From: Patricia Harrell <Pat_Harrell@msn.com>
Sent: Friday, January 27, 2017 11:42 AM
To: Lindsey Ozbolt
Subject: Re: East Lake Sammamish Trail-South Sammamish Segment B section-60% Design Plan comments

Thank you for contacting the City of Sammamish regarding the current Shoreline Substantial Development Permit Application for East Lake Sammamish Trail Segment 2B (SSDP2016-00415).

RE: King County SSDP Permit-- South Sammamish Segment B
Homeowner comments regarding 60% Design Plan
Survey Station 332+00
2221 East Lake Sammamish PL SE

Picture # 3

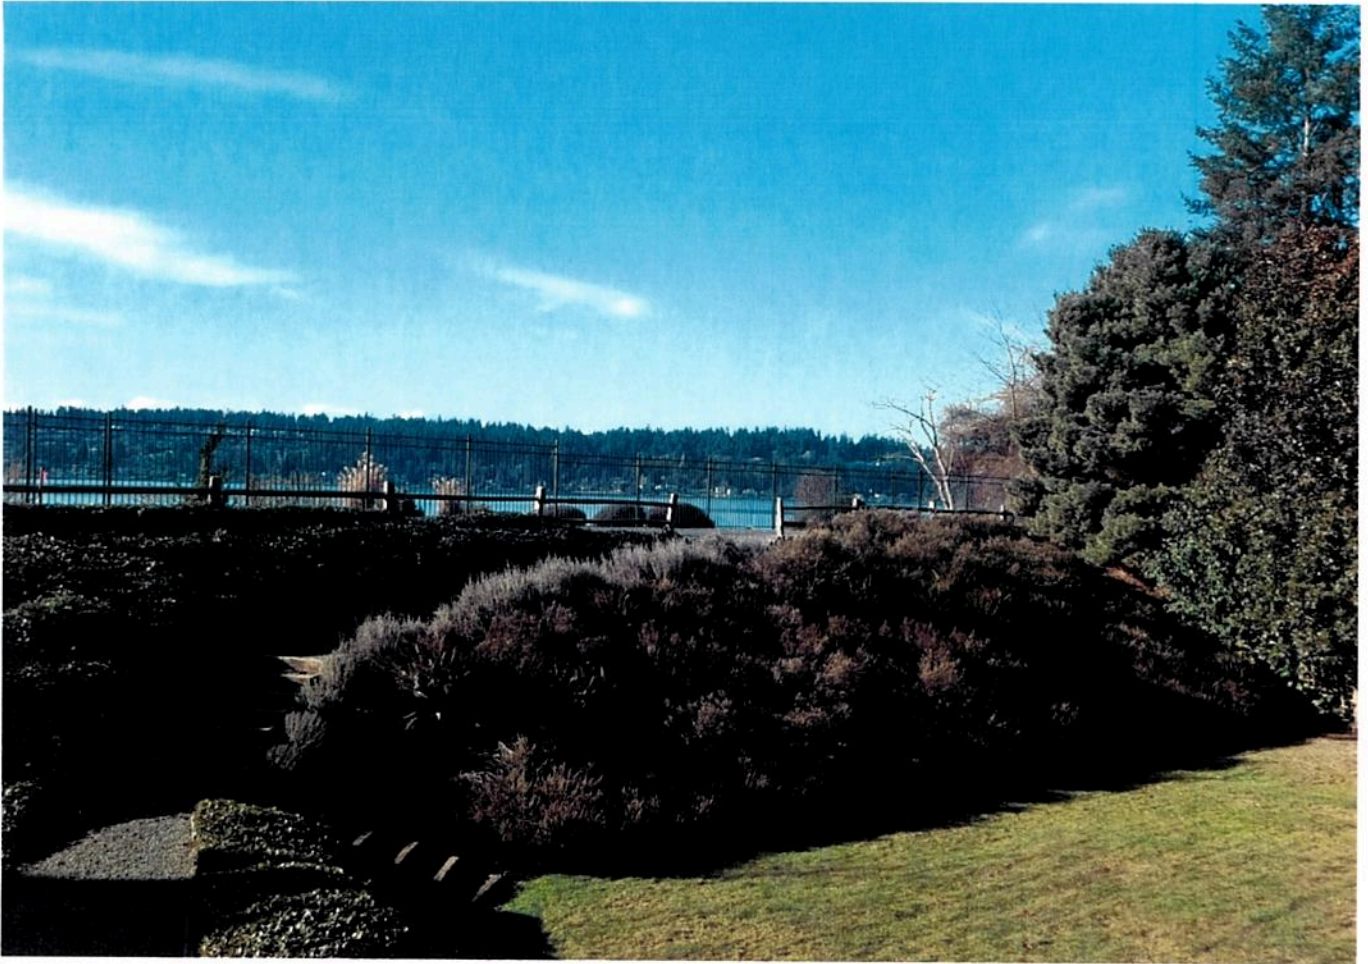
- a. current gate on west side of trail. Plan does not replace
- b. gate allowing access to current trail and to gate a to dock. Plan does not replace, thereby cutting off access as new fence on east side has no gate/access.
- c. Stain #36 removed during construction & not replaced?
- d. Aerial view of lower lawn to be 80% replaced with "WBA" (wetland Buffer Addition)!
- e. Current "substantial" fence to be removed with no plan to replace.

Shows current trail is at grade with fence on west side. Plan calls for removal with no replacement due to need to "clean & grub" 6" to the lake side of current fence line.

Picture # 0

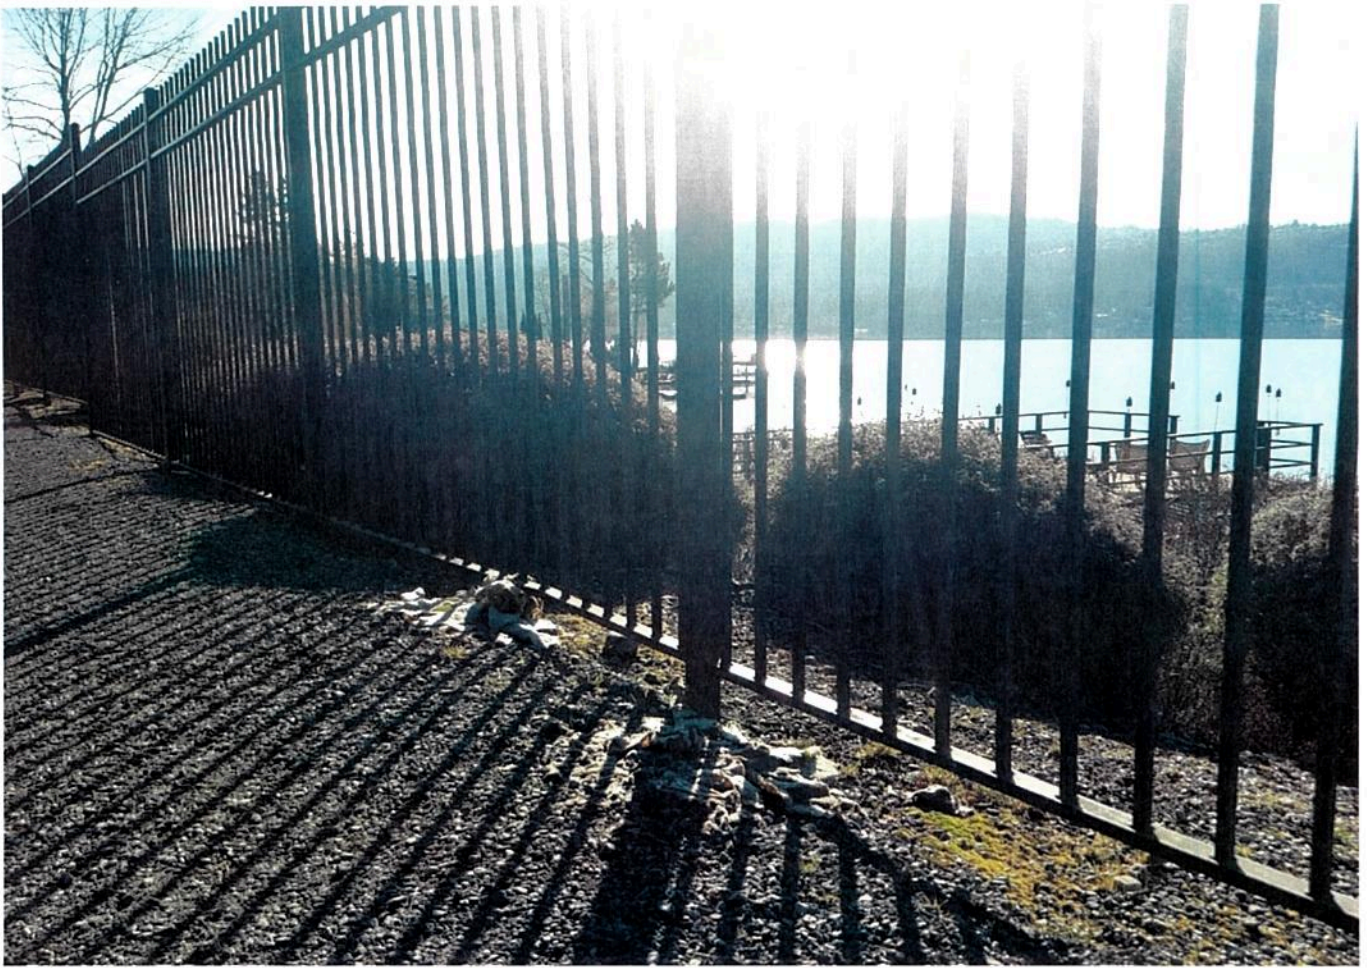
View from lake level showing steep dropoff.
Roughly a 20' dropoff. 60% plan calls to eliminate
west side fence and not replace.

View from Dock of Steep dropoff on west side of the trail. 60% plan eliminates fence with no replacement.

SHEET NO.
117 OF 135
LA5

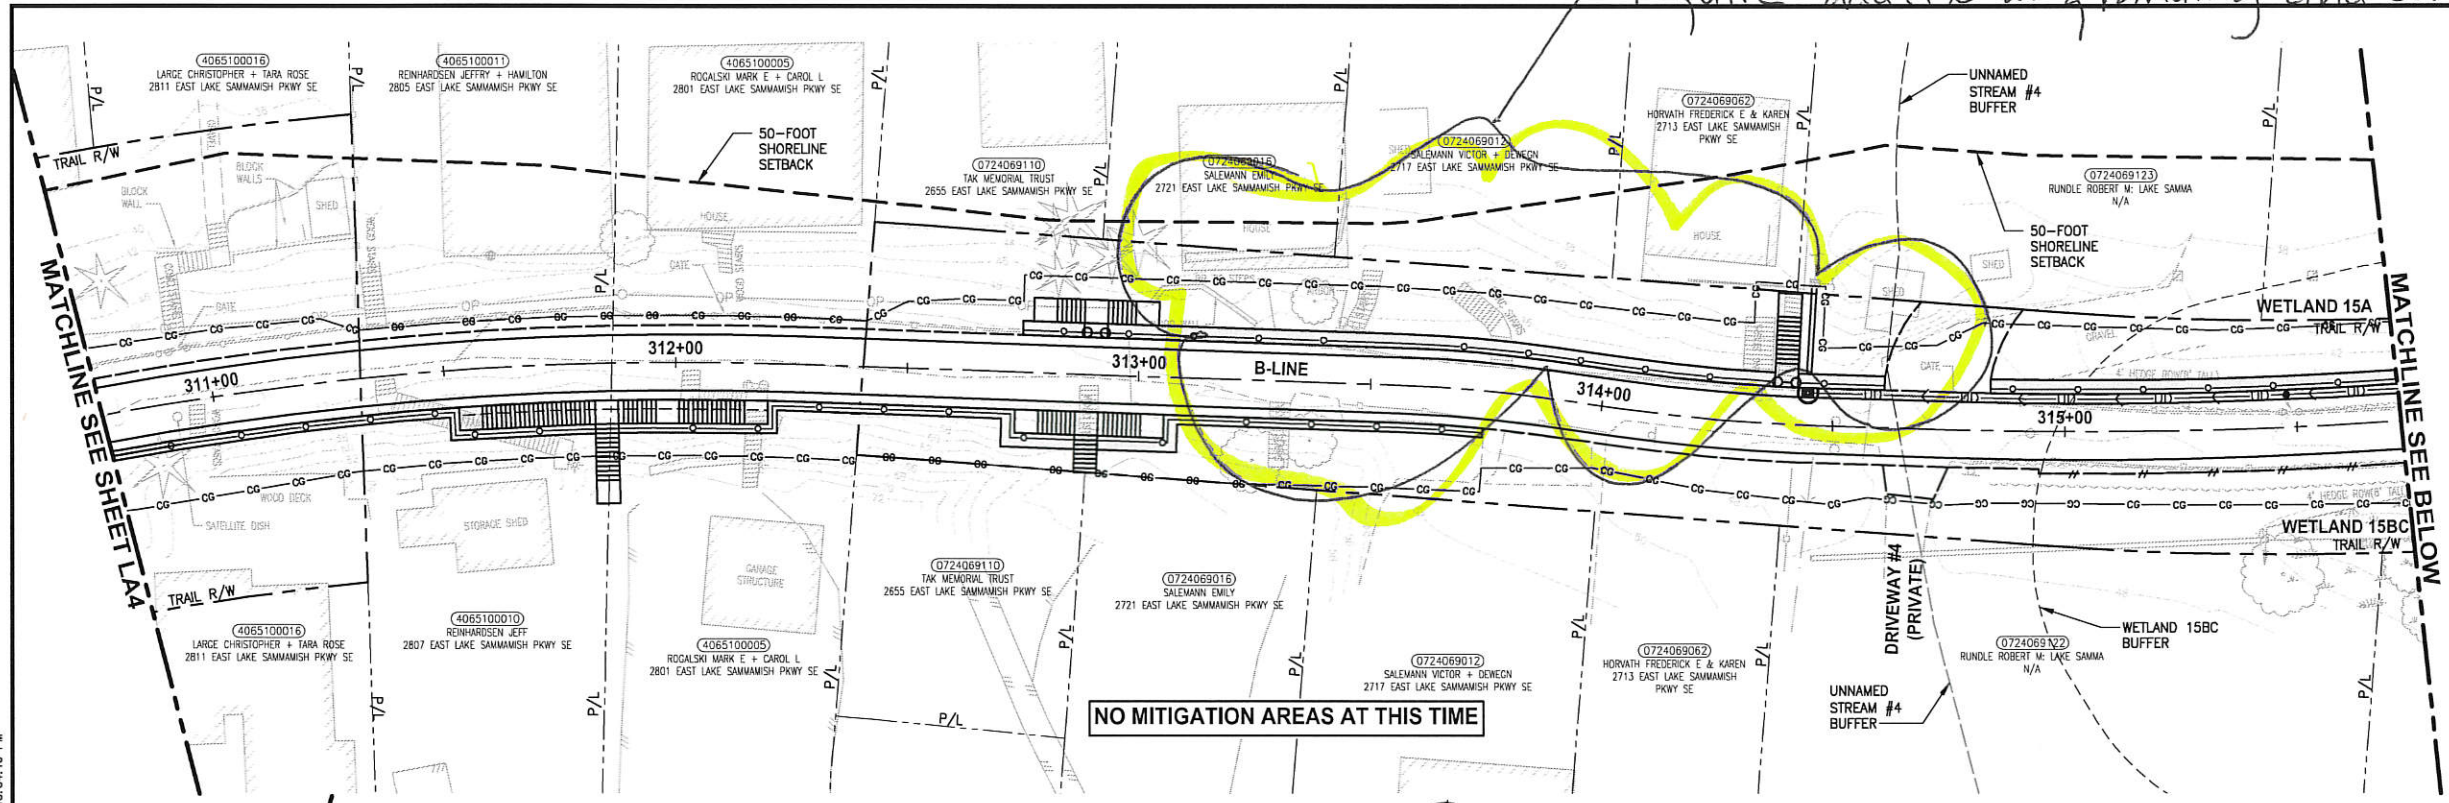
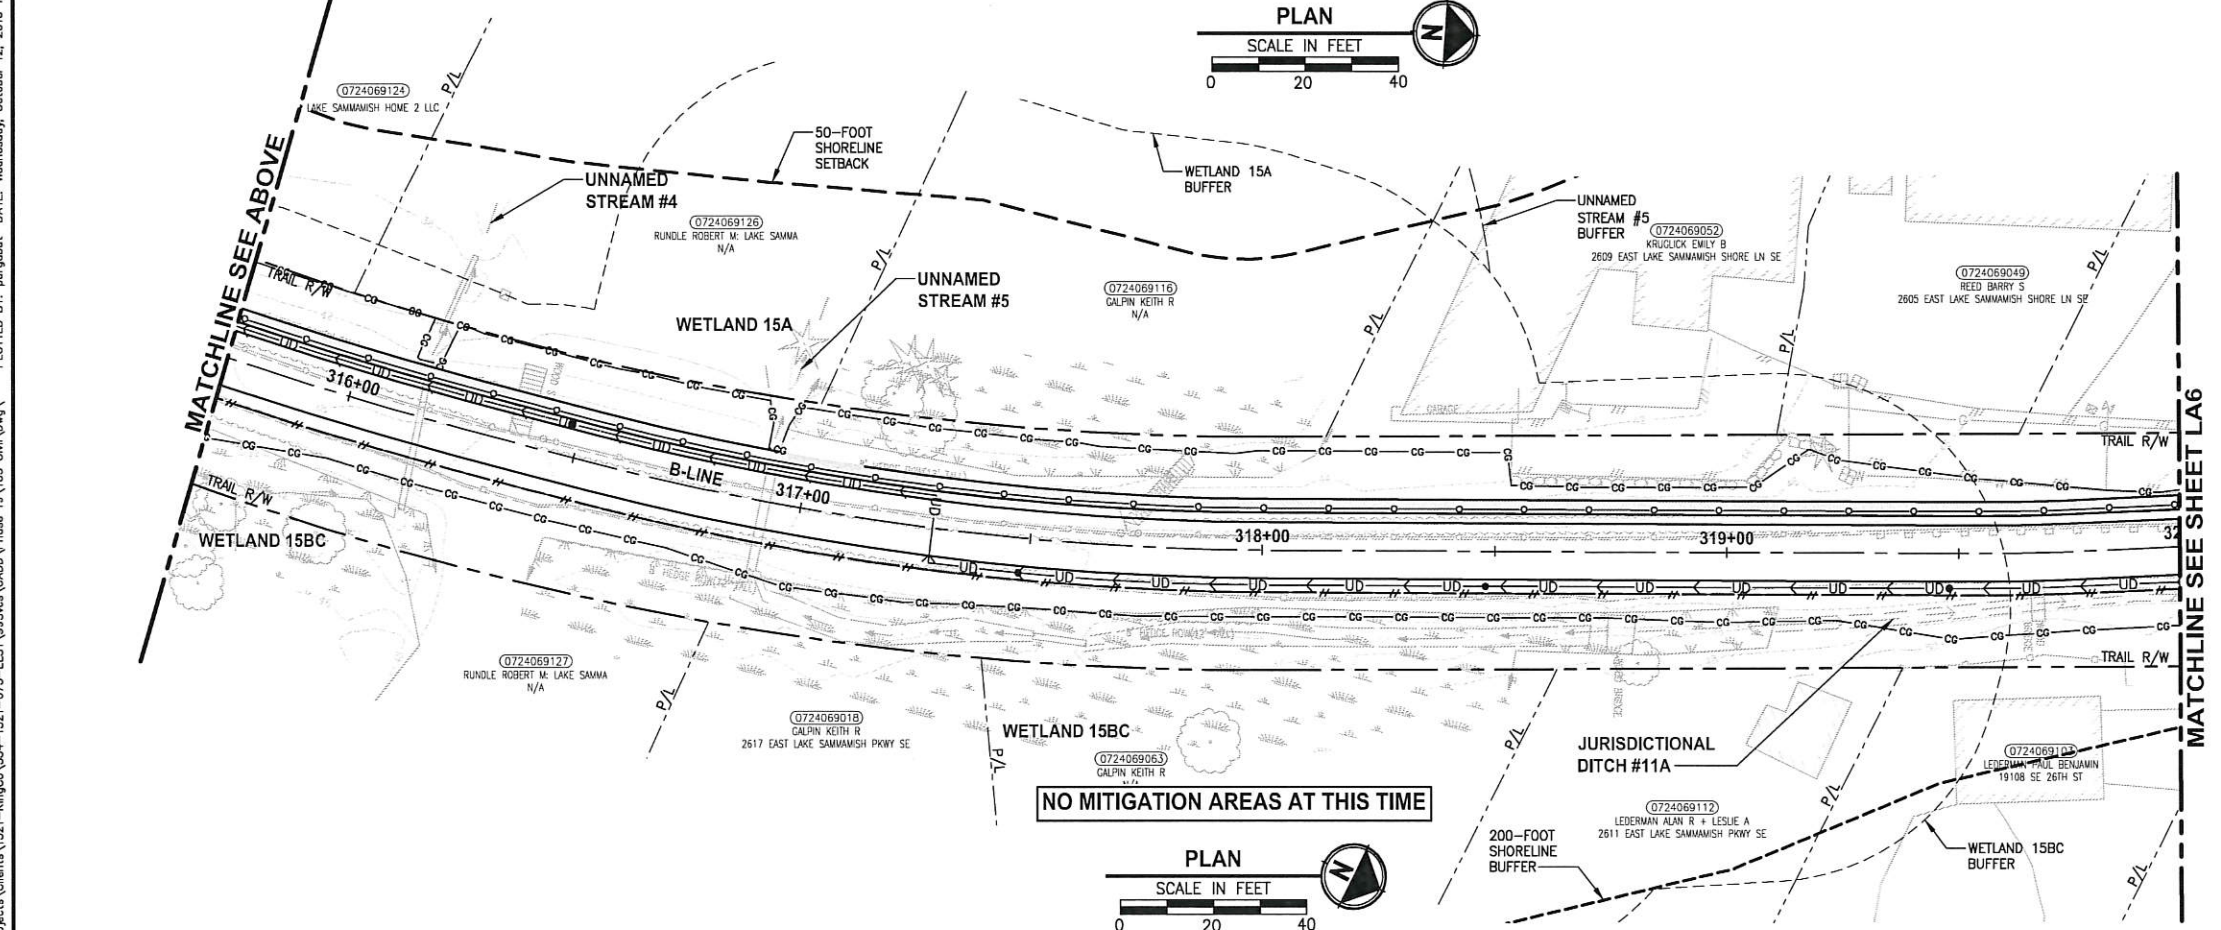
This shared stair arrangement would require additional grading and construction

SHEET NO.
98 OF 135
WP2

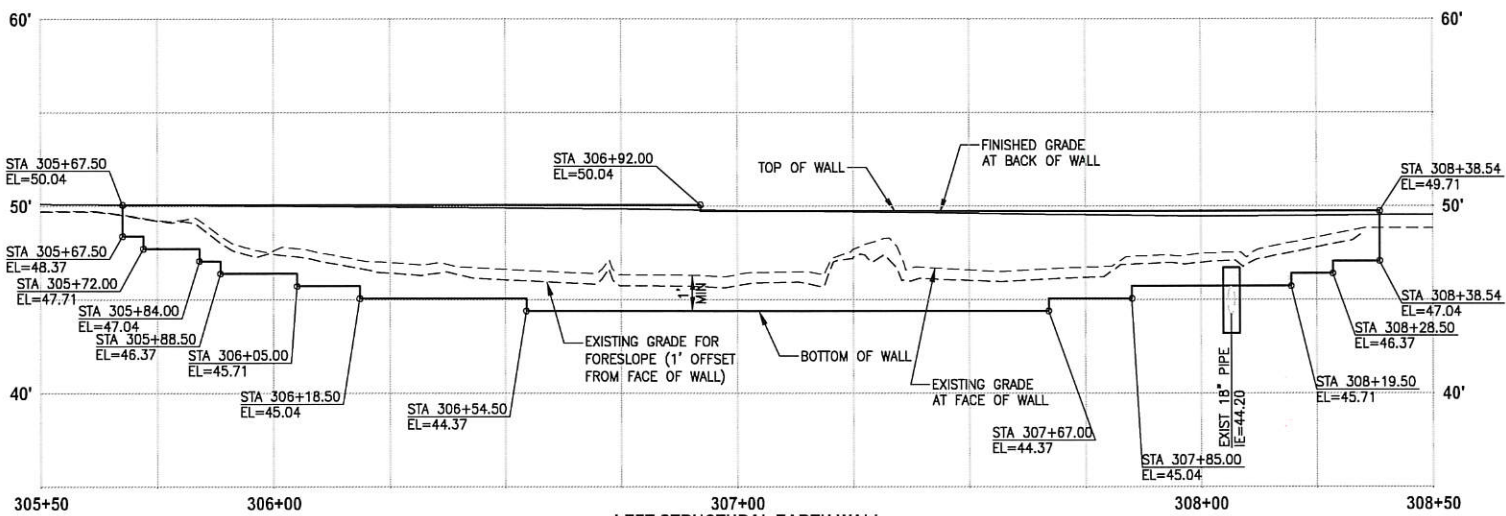
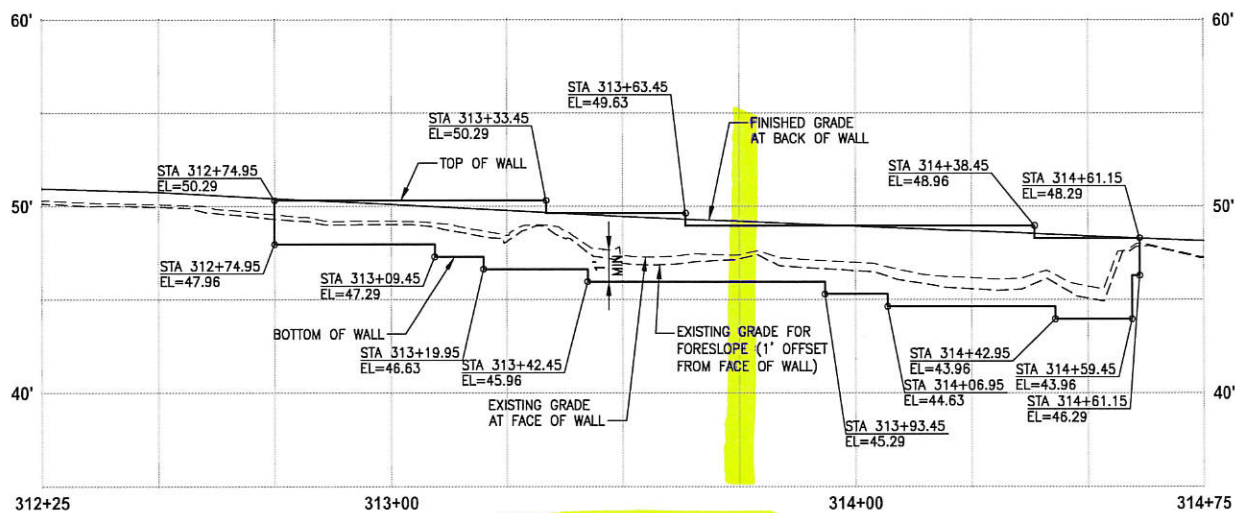
Suggest you verify stability of this wall being built on top of RR fill slope. There is existing seepage at the slope.
